**NINE MILE POINT
NUCLEAR STATION**

SUBJECT: Nine Mile Point Nuclear Station
Unit No. 2; Docket No. 50-410

Supplemental Information Regarding Nine Mile Point Nuclear Station, Unit No. 2 –
Re: The License Amendment Request for Extended Power Uprate Operation (TAC
No. ME1476) – Update to License Amendment Request

SUMMARY OF REVISED PEAK CONTAINMENT PRESSURE ANALYSIS (NON-PROPRIETARY)

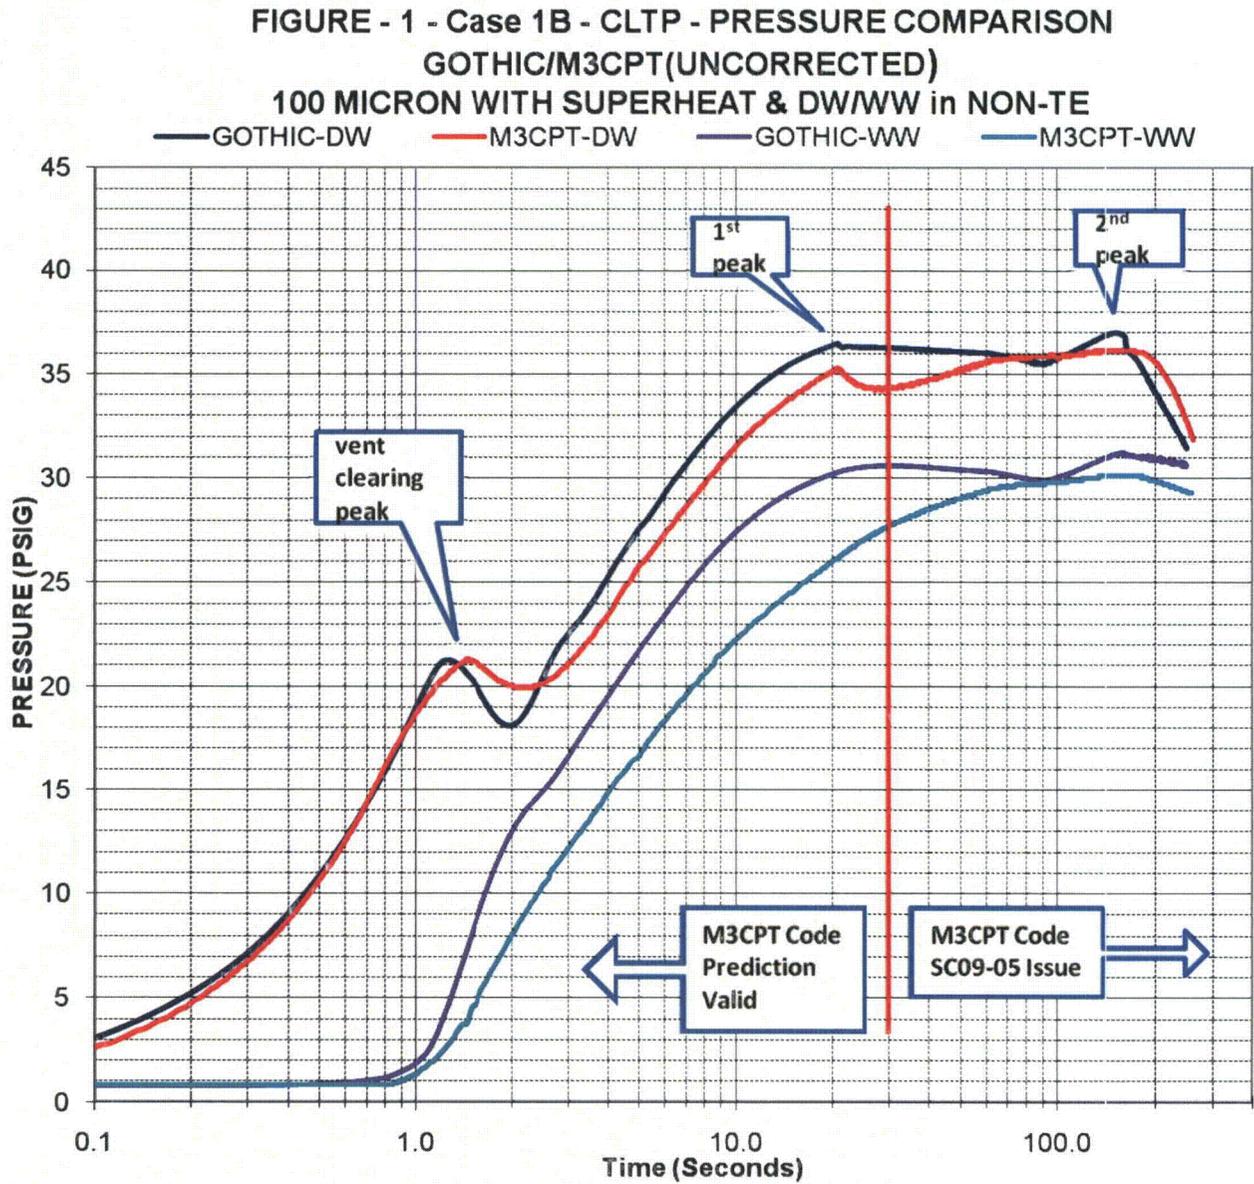
Method	Pressure Peaks (psia @ seconds) – 135°F/40%/90°F			Power Level	Figures
	Vent Clearing Peak	1 st Peak (Blowdown Transition)	2 nd Peak (End of Blowdown)		
M3CPT	36.00 @ 1.44	49.90 @ 20.7	50.84 @ 147	CLTP	Figure 1
GOTHIC 7.2b	35.96 @ 1.25	51.18 @ 20.7	51.71 @ 148	CLTP	Figure 1
M3CPT	35.94 @ 1.44	50.24 @ 20.2	51.96 @ 149	EPU	Figure 2
GOTHIC 7.2b	35.95 @ 1.25	51.35 @ 21.2	51.87 @ 152	EPU	Figure 2

Note: The red vertical line implies that the M3CPT Code SC09-05 issue begins at 30 seconds. This is an approximation. The issue does not have a specific start time, but it is judged to occur after the time shown in the figure.

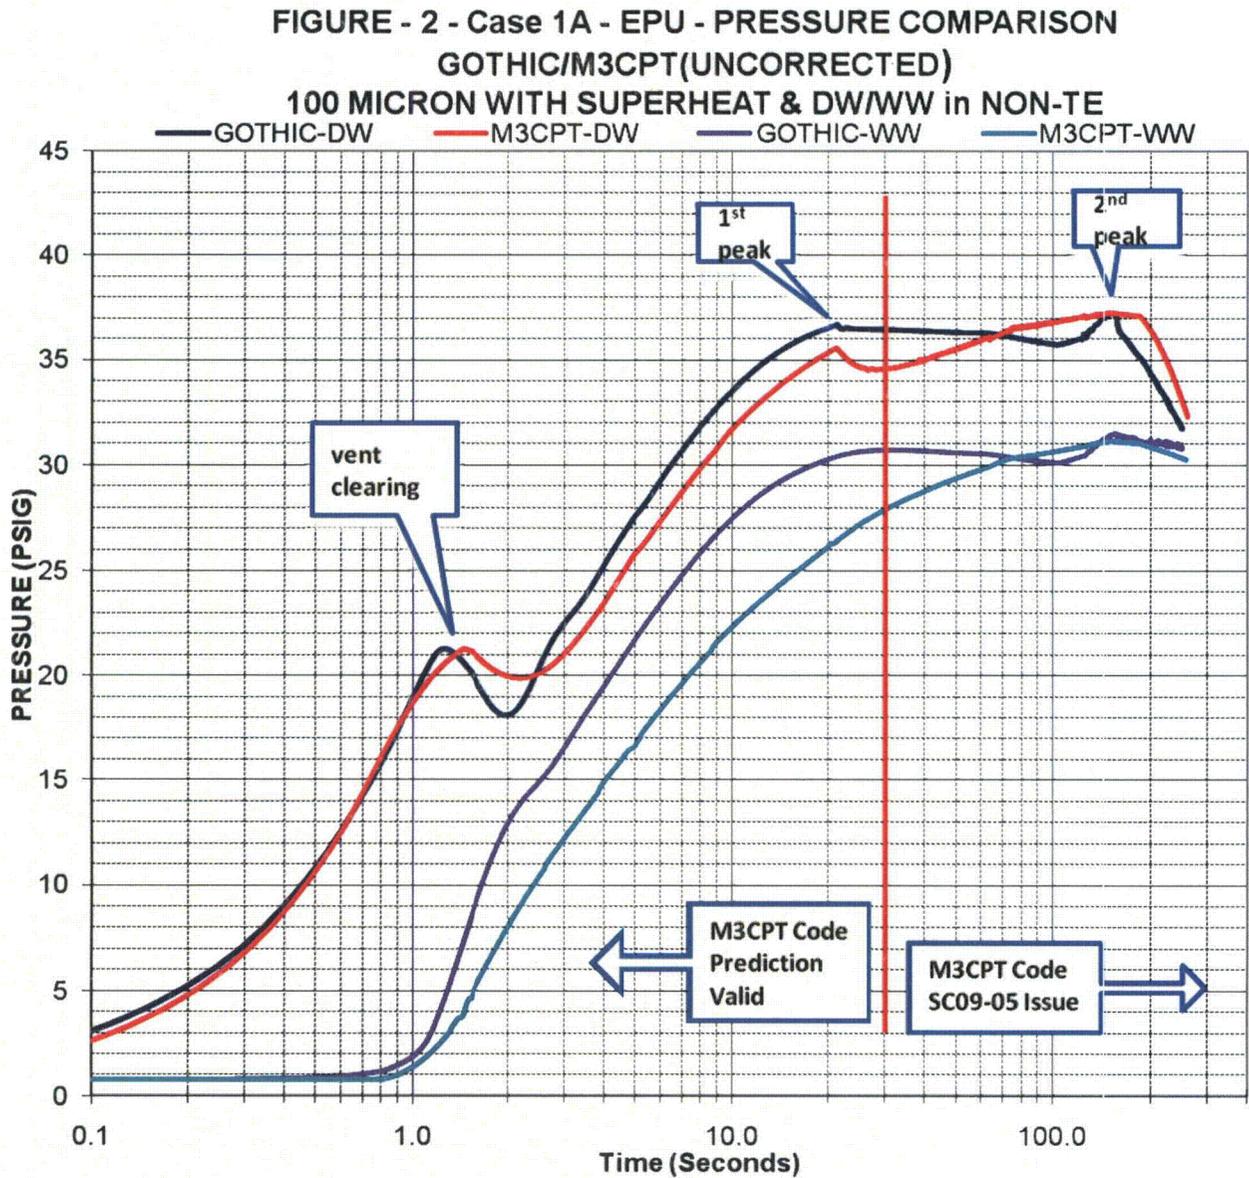
Note: The red vertical line implies that the M3CPT Code SC09-05 issue begins at 30 seconds. This is an approximation. The issue does not have a specific start time, but it is judged to occur after the time shown in the figure.

FIGURE 3 - CASE 2 & 2B - EPU GOTHIC PRESSURE RESPONSE
- 105/40/90 VS. 107/48/83

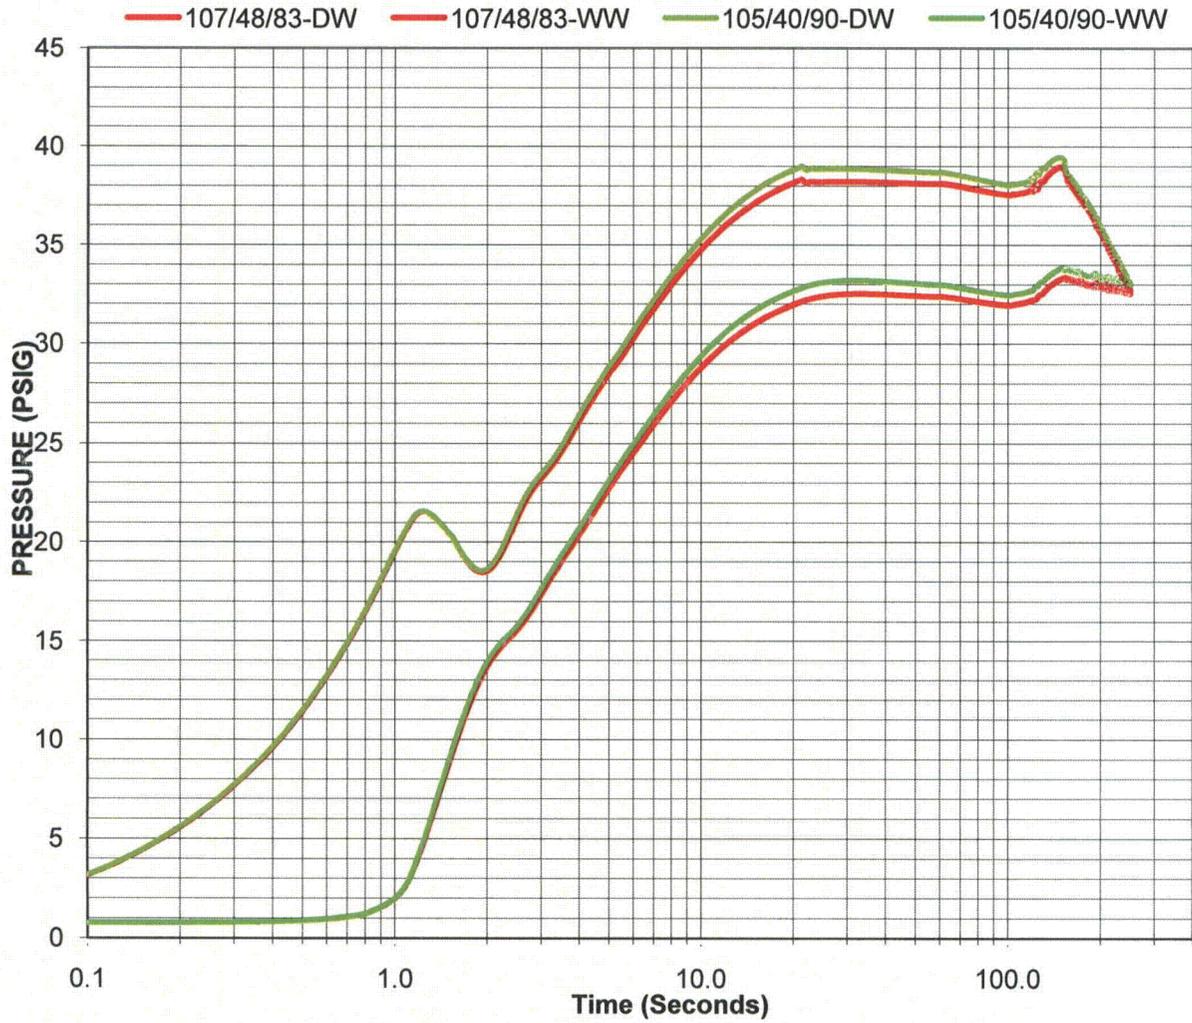
- GOTHIC Case 2B utilizes lower bound initial conditions of drywell temperature of 105°F, drywell relative humidity of 40%, and suppression pool temperature of 90°F.
- GOTHIC Case 2 utilizes a drywell temperature of 107°F (conservative lower bound on the 108.7 °F), drywell relative humidity of 48%, and suppression pool temperature of 83° based on operating plant data review. This case demonstrates the margin with respect to a 97.5 percentile case at 100% power normal operating conditions.
- GOTHIC Case 2A utilizes the initial conditions of drywell temperature of 110°F (mean drywell temperature), drywell relative humidity of 40%, and suppression pool temperature of 90°F. This establishes the sensitivity on drywell temperature while maintaining the other initial conditions at the same values as GOTHIC Case 2B.

The revised containment analysis (GOTHIC Case 2B) determined that the peak containment pressure was 54.2 psia (39.5 psig). This value is lower than the value of P_a established in NMP2 Technical Specification 5.5.12.b of 39.75 psig (54.45 psia).

Figure 2.6-7 of Attachments 3 and 11 of the NMP2 EPU License Amendment Request dated May 27, 2009 is replaced by Figures 3, 4, and 5 of this submittal. Figure 5 of this submittal shows the Short-Term M3CPT pressure profile used for dynamic loadings. Figures 3 and 4 show the Extended Short-Term GOTHIC pressure profiles used for containment peak pressure analyses.

FIGURE 4 - CASE 3 - EPU PRESSURE RESPONSE (70/20/90)

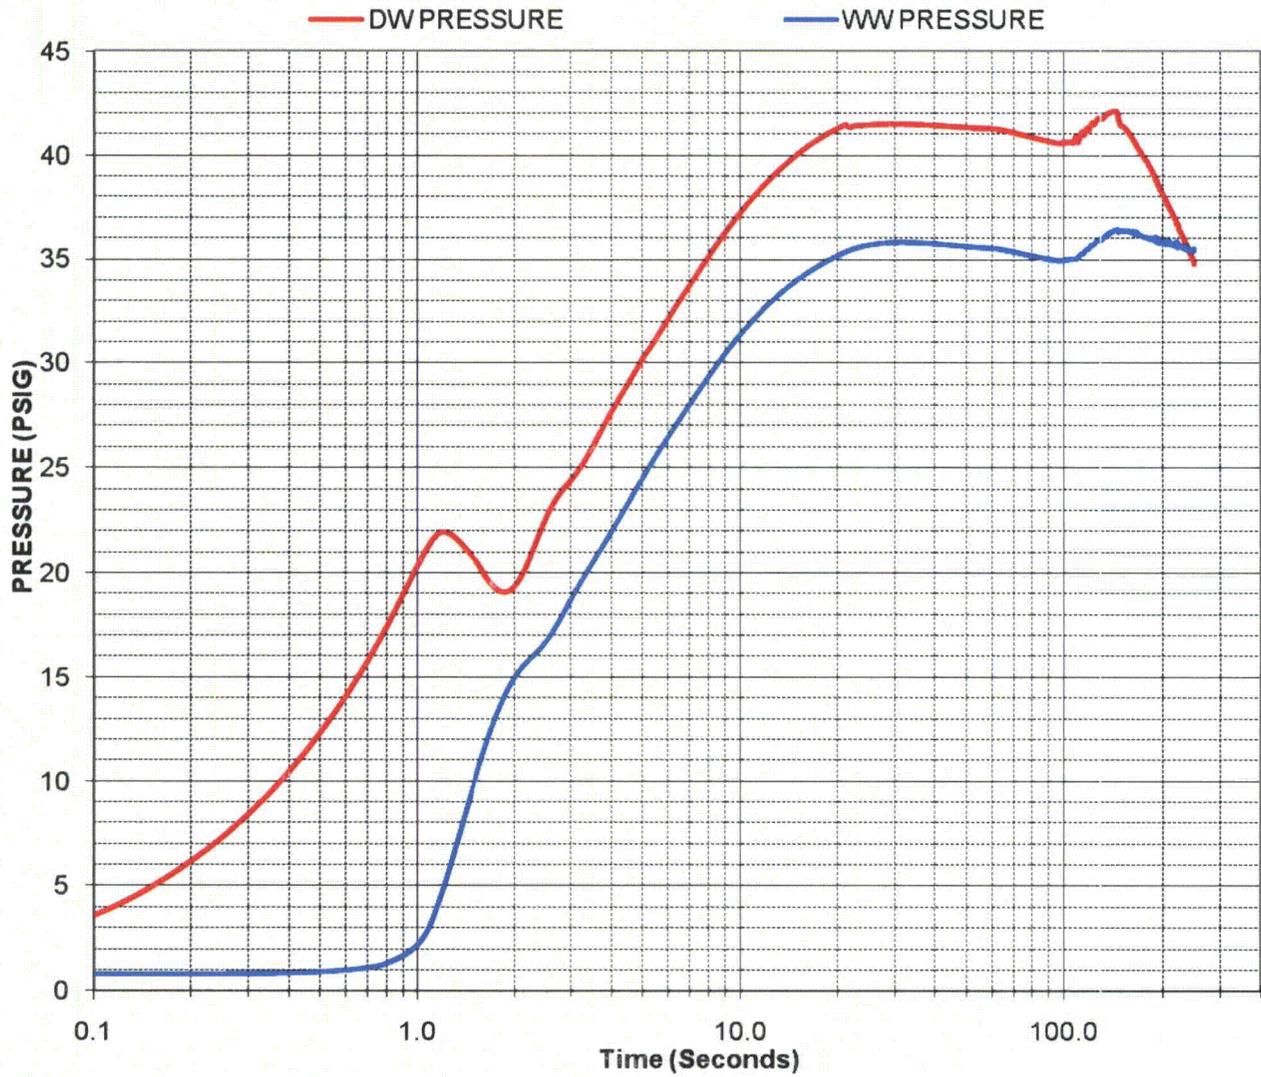
An analysis was performed to ensure that the drywell accident pressures would not exceed design pressure based on the worst combination of initial conditions. GOTHIC Case 3 establishes that the calculated peak containment pressure at the USAR lower bound conditions of drywell temperature of 70°F, drywell relative humidity of 20%, and suppression pool temperature of 90°F is lower than the containment pressure design value of 45 psig (59.7 psia).

Table 2.6-1 of Attachments 3 and 11 of the NMP2 EPU License Amendment Request dated May 27, 2009 identifies that the peak drywell and wetwell pressures for the design basis LOCA EPU with the EPU model as 52.9 and 47.1 psia respectively. The revised containment analysis (GOTHIC Case 3) determined that the peak drywell and wetwell pressures are 56.78 and 51.2 psia. The EPU peak containment pressure is less than the 59.7 psia (45 psig) design pressure.
